Product Change Notification

1. ECR #: 206161
Notification #: 593

- JSOM - MICRO JACK SCREW STAND-OFF

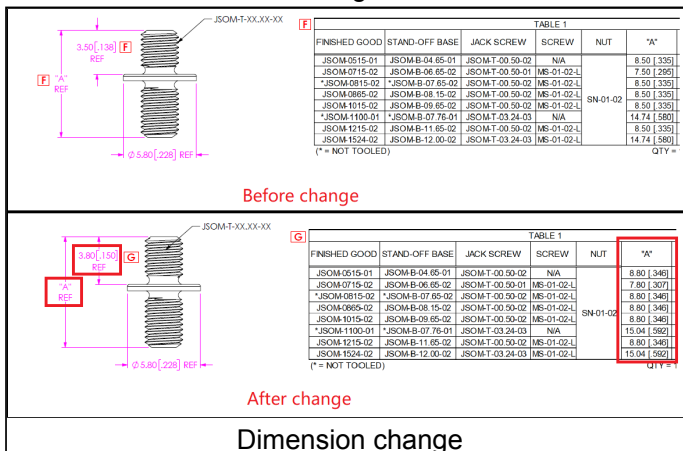
This notification reverses changes made on revision F and Notification # 590. (FIG 1: CHG 3.50 REF TO 3.80 REF; TABLE 1: ALL OPTIONS: INCREASE "A" BY 0.30.)

This notification reverses changes made on revision F and Notification # 590. Samtec did not complete the changes on revision F and product was not shipped to customers with the JSOM at 3.50 mm top-stud length. No changes will be made on the standard JSOM (3.8mm REF will remain as-is). ASP versions will be changing to 3.5mm REF (ASP-198471-XX for M2.5 thread, ASP-199169-XX for M3 thread & ASP-199167-XX for # 4-40 thread). Please kindly see <https://www.samtec.com/standards/vita/fmc#vita57fmcinformation> for more information.

- Form - 3.80 mm top-stud length will allow a thicker PCB application.
- Fit - 3.80 mm top-stud length will require an increased application clearance.
